CNRO-2005-00054

SUBJECT: Grand Gulf Early Site Permit Application Revision 1 Corrections (TAC NO. MC 1378)

**GGNS ESP APPLICATION - REVISION 1 CHANGE SUMMARY
PART 4, EMERGENCY PLANNING INFORMATION
(CORRECTED)**

ESP APPLICATION PART 4, REVISION 1
CORRECTED PAGES

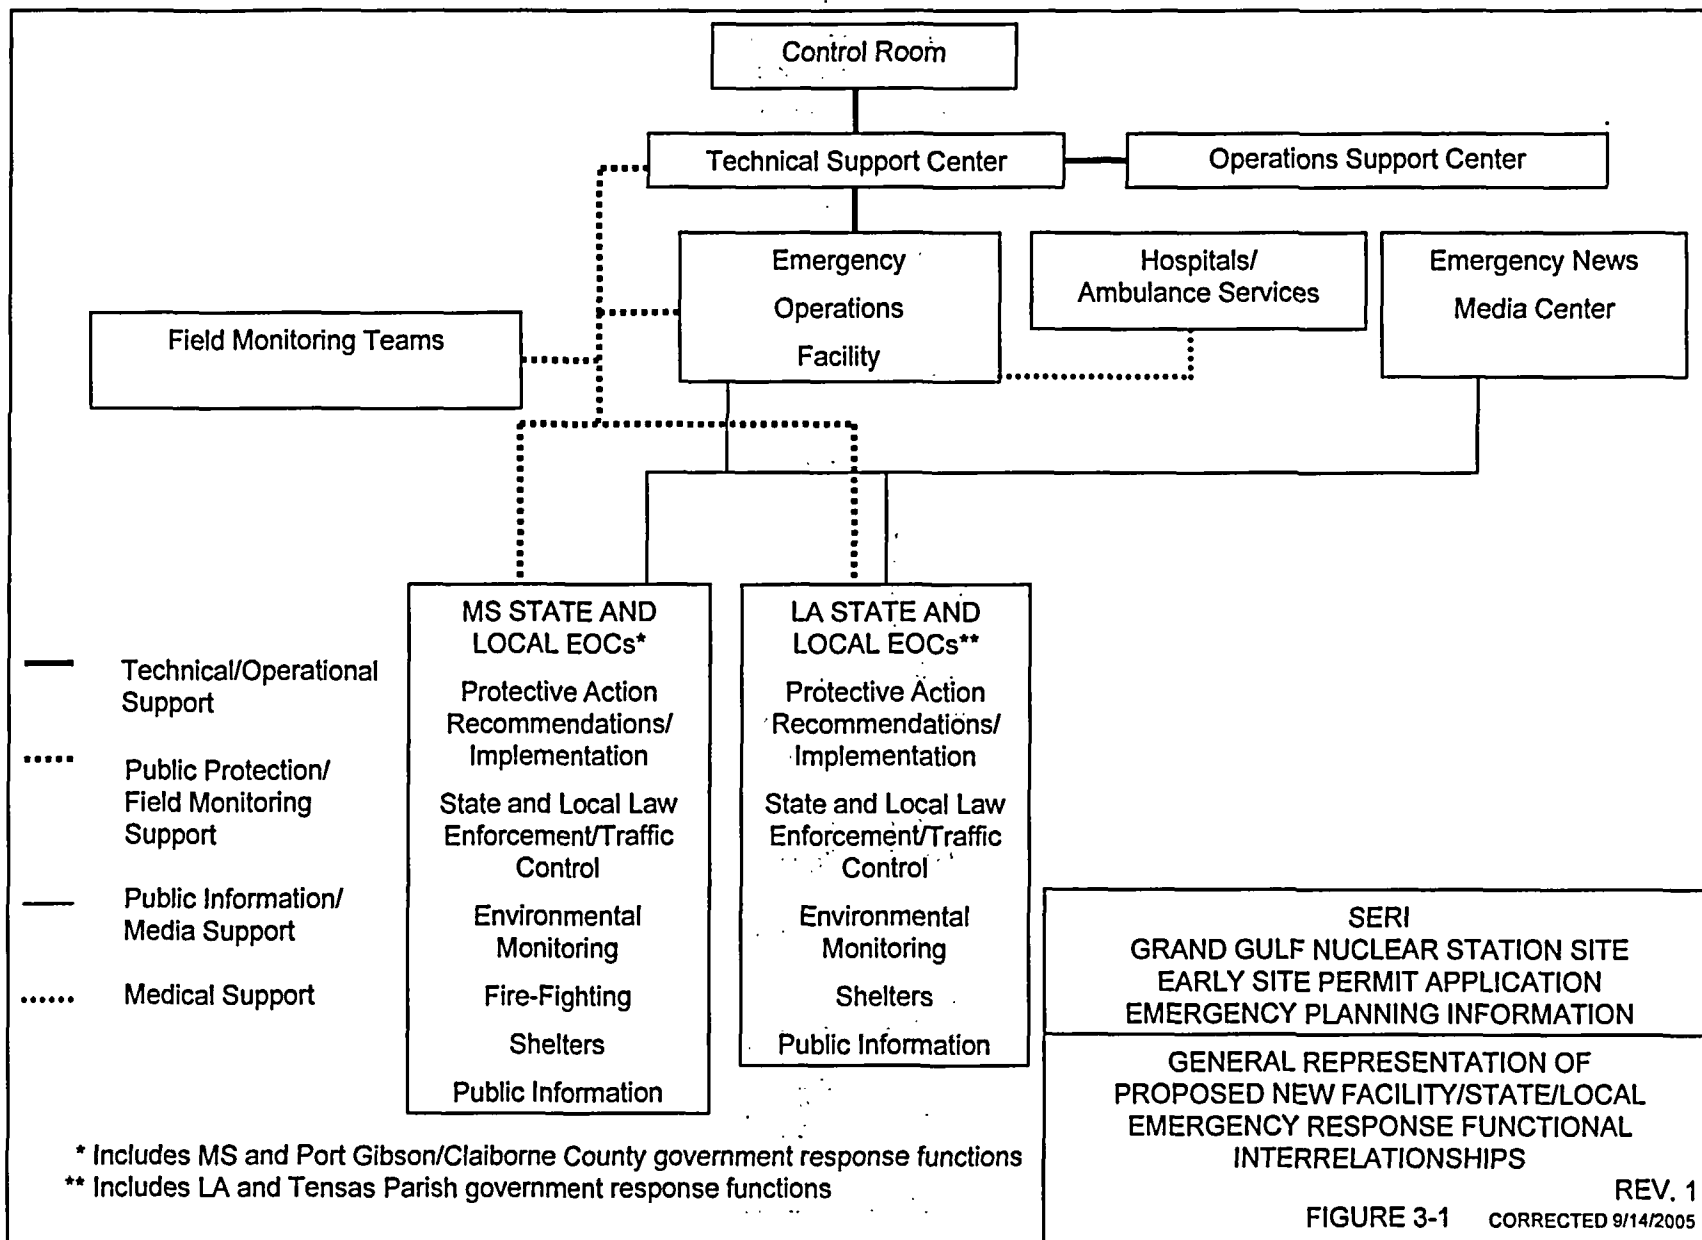
Action #2: Provide justification for deleting changes made to Figure 3-1 and Table 4-1 in draft Revision 2 made to address RAIs 13.3-13 & -57, or restore changes identified in draft Revision 2.

The version of Figure 3-1 and Table 4-1 in the draft Revision 2 document should have been incorporated into the Revision 1 files. They were inadvertently omitted. Corrected Tables are included with this letter.
